Item Name: Aft Facing Seat Assembly, LH

DART SERVICE INSTRUCTION

TO AMEND INSTALLATION INSTRUCTIONS IIN-D412-769 REV. C AND
INSTRUCTIONS FOR CONTINUED AIRWORTHINESS ICA-D412-769 REV. 1

DRAWING NO. D412-769-1	TITLE AFT FACING SEAT ASSY, LH	REV. B	DART AEROSPACE LTD ENGINEERING ORDER	D.E.O. NO. D412-769-1-B-1	SHEET NO. SHEET 1 OF 2	SCALE NTS
DRAWN	CHECKED <i>UP</i>	MFG. APPR. <i>[Signature]</i>	APPROVED <i>[Signature]</i>	DE APPR. <i>[Signature]</i>		
DATE 12.07.09	DATE 12/7/10	DATE 12.07.10	DATE 12.07.10	DATE 12.07.10

Figure 1: Addition of D4679-1 Spacer
(D412-769-041 shown, D412-769-042 similar)

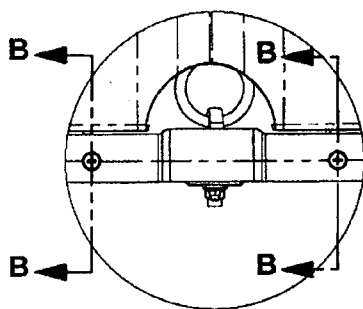
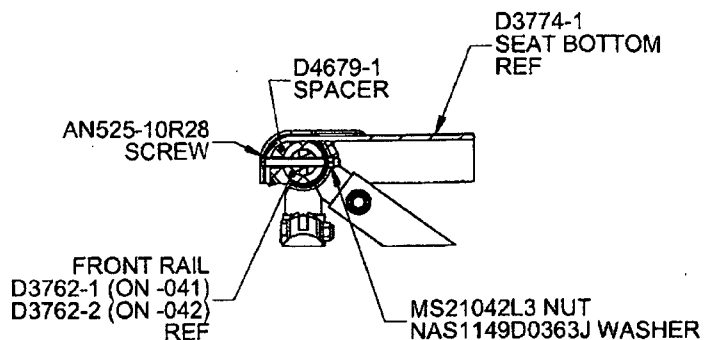
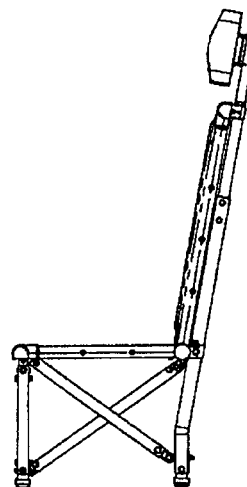
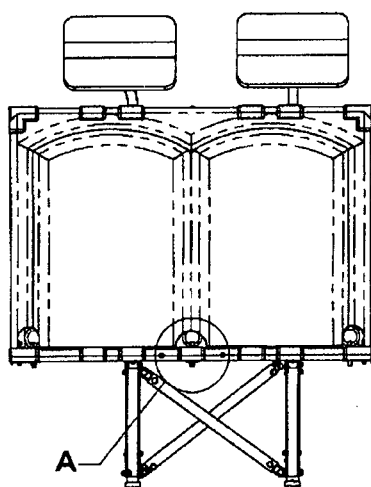
The purpose of this DSI (Dart Service Instruction) is to inform customers and operators that qty(2) D4679-1 Spacers were added to D412-769-011 Aft Facing Seat Kit and D412-769-041/-042 Aft Facing Seat, LH/RH at CHG 002 or later. This change also affects the hardware as shown in Figure 1 of this service instruction.

Qty -011	Qty -041	Qty -042	Part Number	Description
X			D412-769-011	AFT FACING SEAT KIT
1	X		D412-769-041	AFT FACING SEAT, LH
1		X	D412-769-042	AFT FACING SEAT, RH
	1		D412-769-043	AFT FACING SEAT ASSEMBLY, LH
		1	D412-769-044	AFT FACING SEAT ASSEMBLY, RH
	2	2	D4679-1	SPACER (ADD)
	11	11	AN525-10R22	SCREW (WAS QTY 13)
	2	2	AN525-10R28	SCREW (ADD)
	11	11	NAS1149D0332J	WASHER (WAS QTY 13)
	23	23	NAS1149D0363J	WASHER (WAS QTY 21)

DETAIL L
SEAT BOTTOM ATTACH - FRONT DETAIL
2 PL

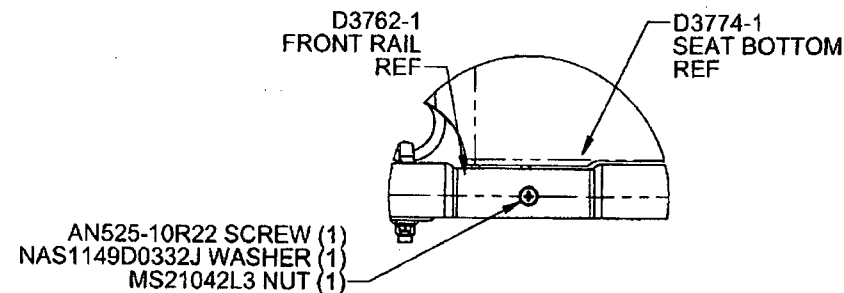
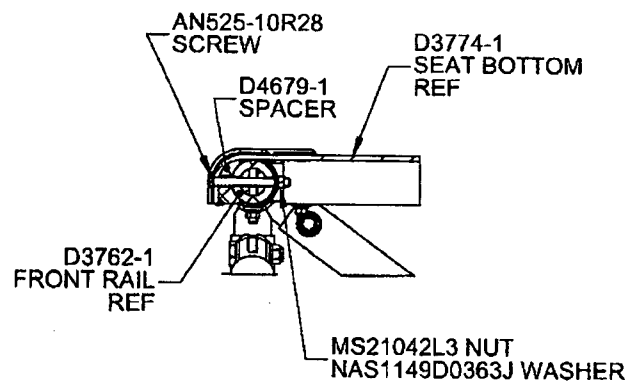
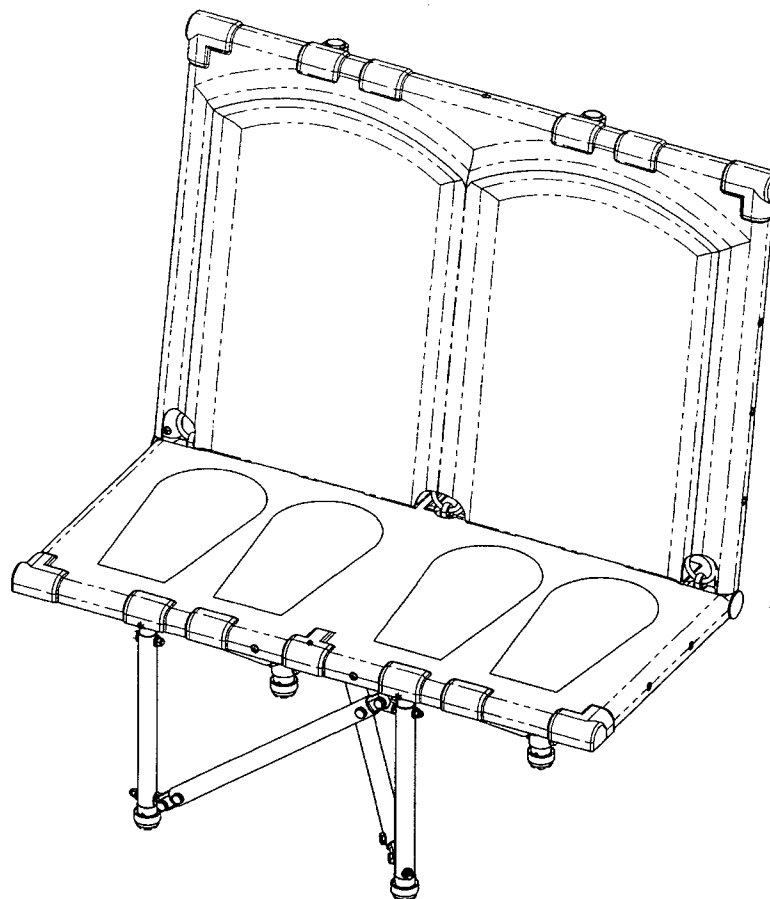
CHANGE:

IS:

SECTION P-P
INSTALLATION OF D4679-1 SPACER
2 PL

DETAIL L
SEAT BOTTOM ATTACH - FRONT DETAIL
2 PL

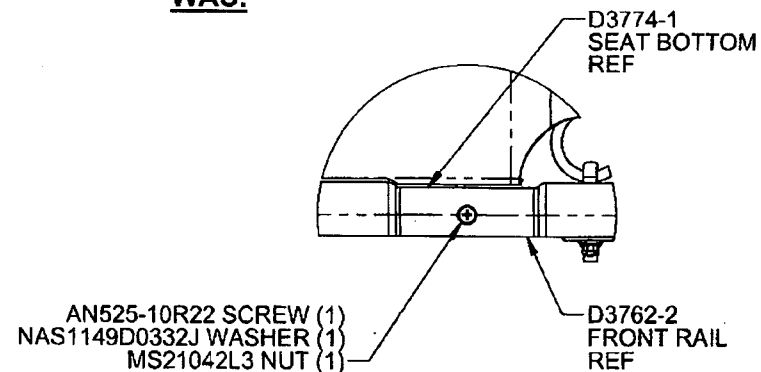
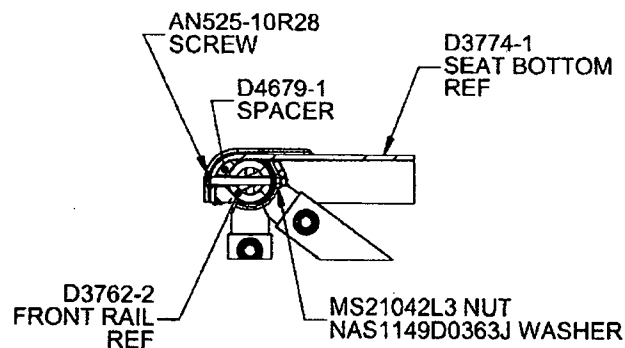
CHANGE:

IS:

SECTION P-P
INSTALLATION OF D4679-1 SPACER
2 PL
